North Campus Faculty Housing Phase II  
Project No. FM110407L/986315

**Addendum No. 6**

ADDENDUM NUMBER 6  
to the  
CONSTRUCTION DOCUMENTS

BUILDING 400A: SECTIONS 1

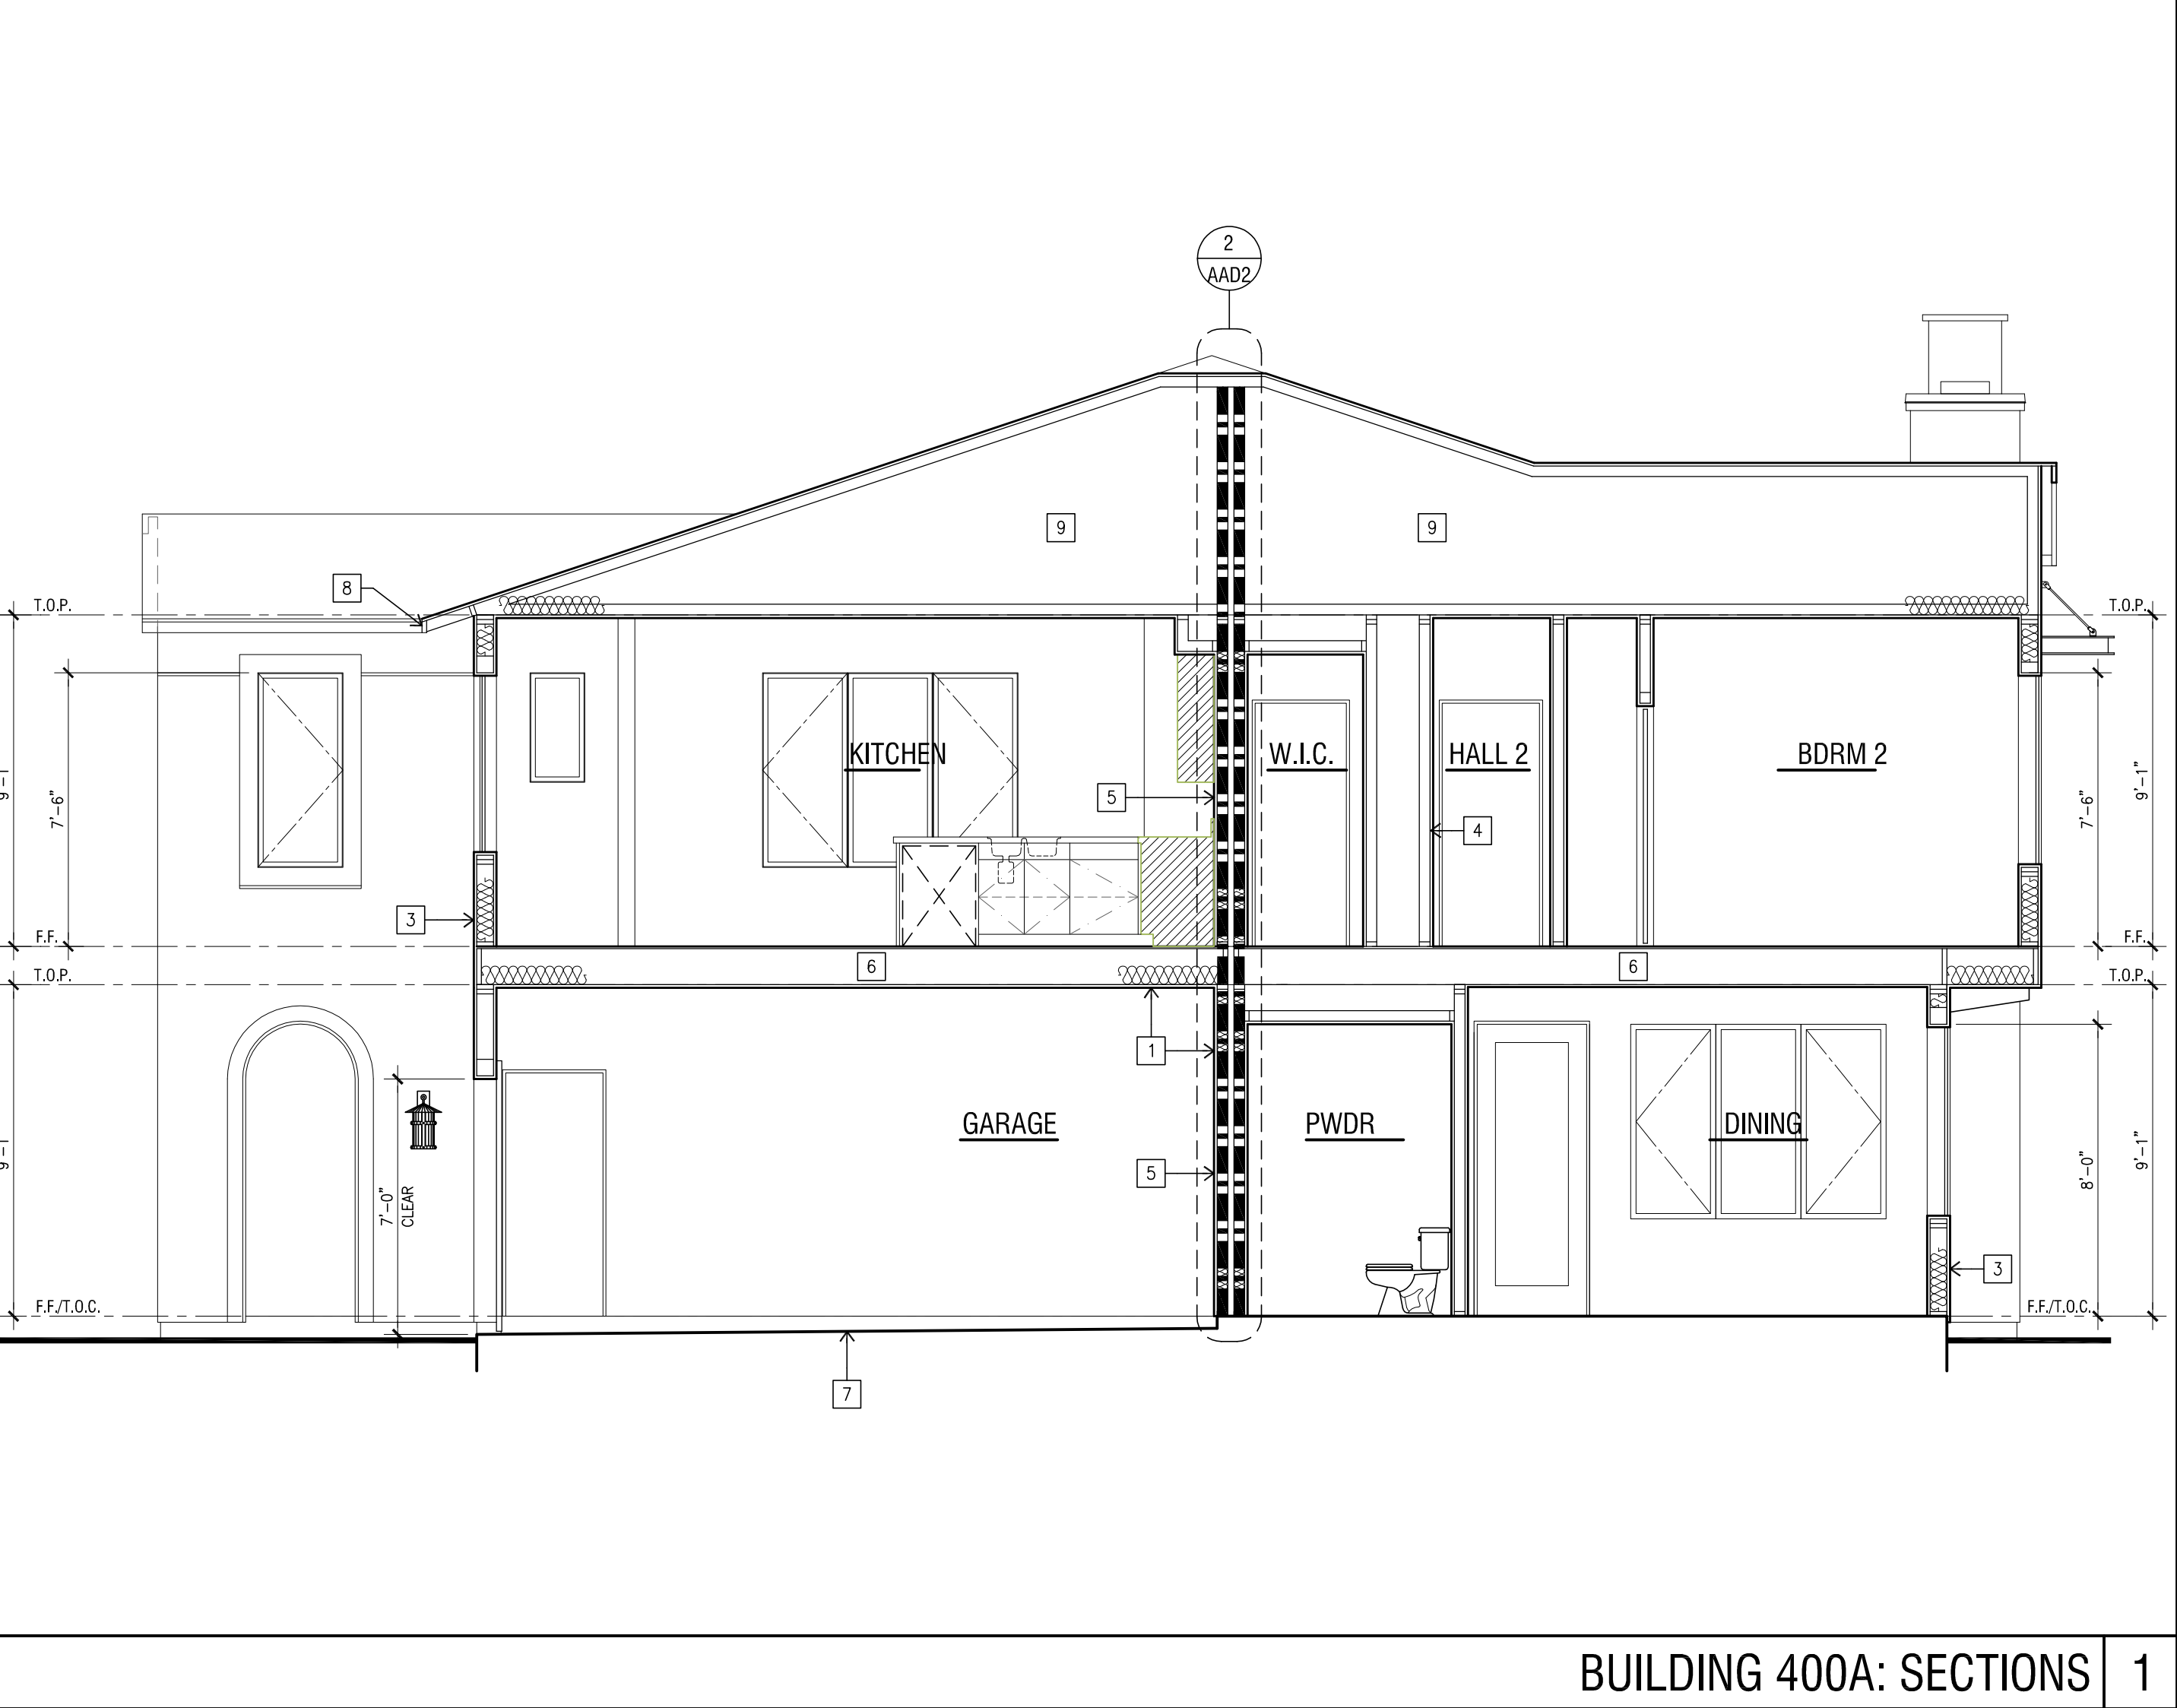
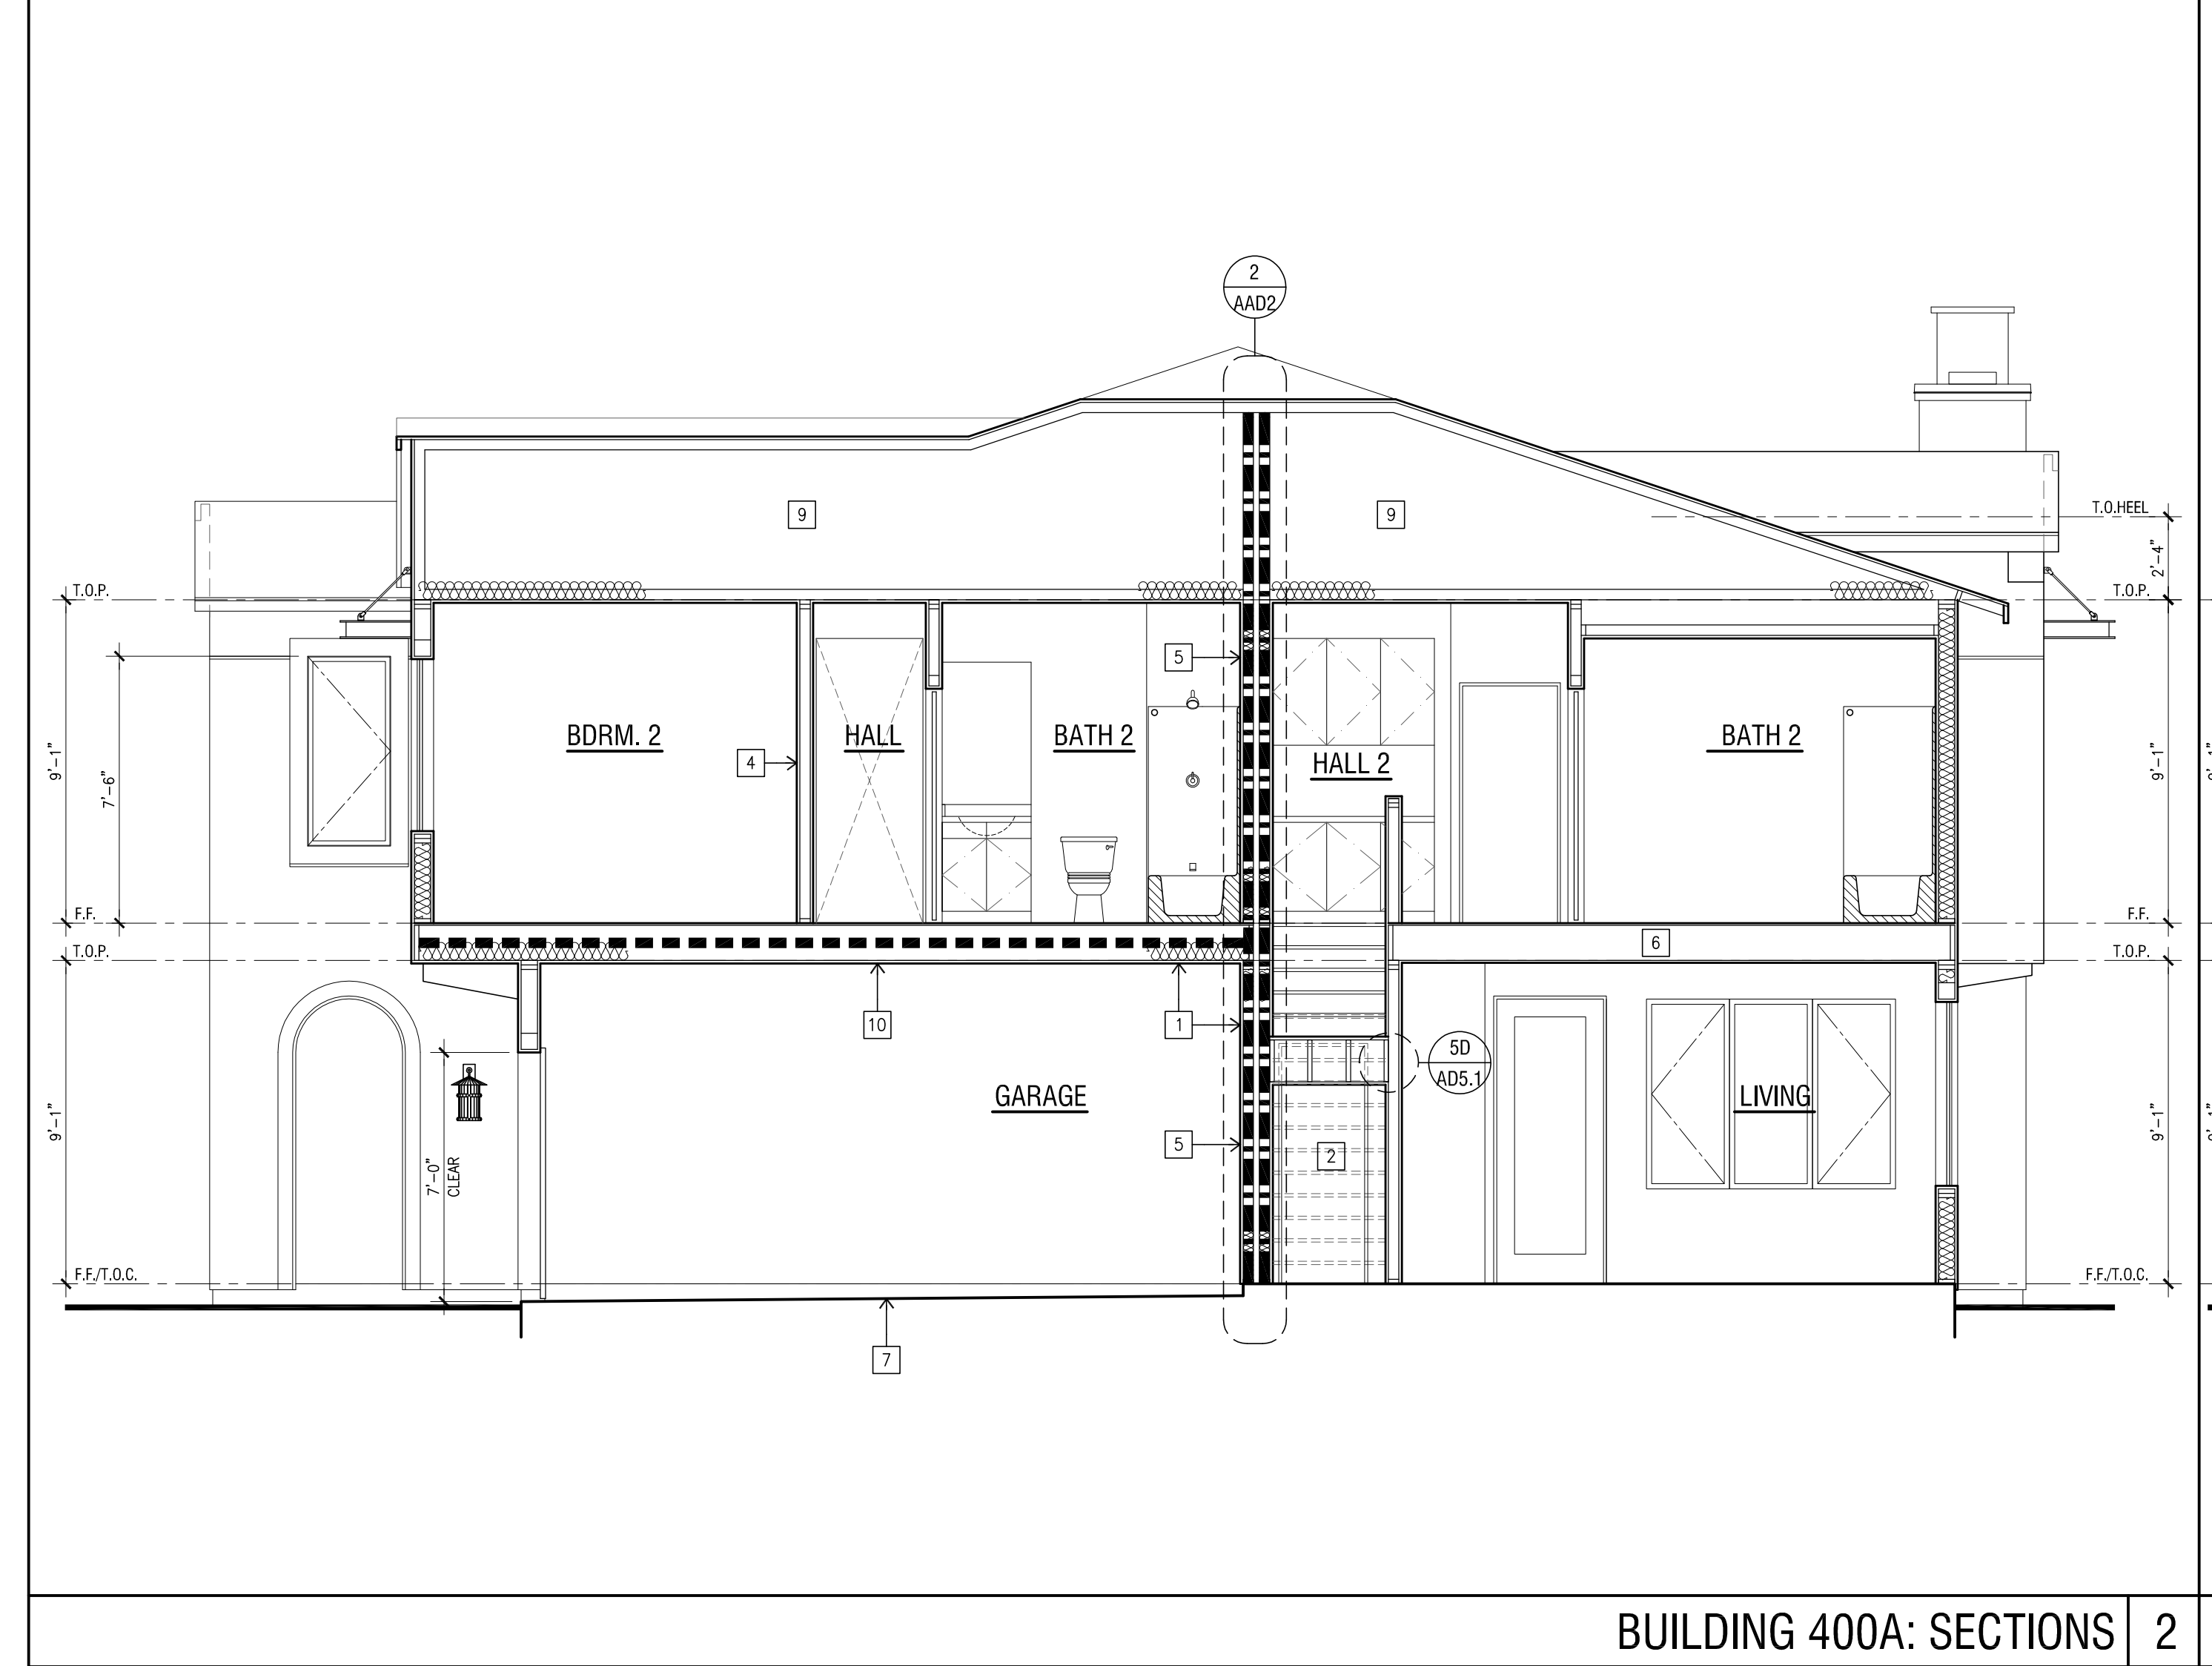
1. **Add** the attached Architect Sketches 1 of 8, dated 9/23/11.  
Sketch 1 of 8 Building 400A: Sections  
Sketch 2 of 8 Building 400B: Sections  
Sketch 3 of 8 Building 500B: Sections  
Sketch 4 of 8 Building 600A: Sections
